# Std. Hitch components - S40M

EC204U, EC206U, EC206BU/EC106, EC02U, EC05B, RFS40M, TFS40M

Replaced from 2026-02

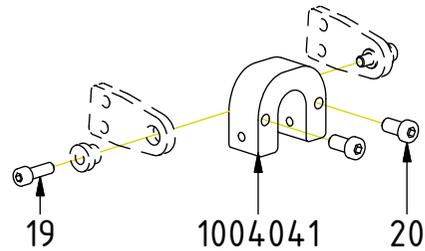
POS	DESCRIPTION	PART	QTY	COMMENTS
1	Shaft Mech. Lock	1004040	1	
7	Washer TBR5B FZB 8,4x26x5	611014	1	
8	Screw MC6S M8x20 12.9 ZFSHL	6000157	5	Loxeal 83-52 to POS.1
19	Screw MC6S M8x25 12.9 ZFSHL	6000143	2	
20	Screw MLC6S M10x20 8,8 FZB	610714	2	Loxeal 83-52
21	Weld the nut to the shaft		1	Procedure replaced by POS.7-8 from 2019-09

Replaced from 2019-09

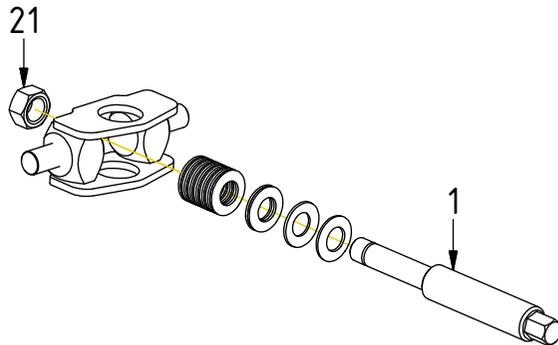
Replacing welding with current solution:  
Shaft must also be replaced
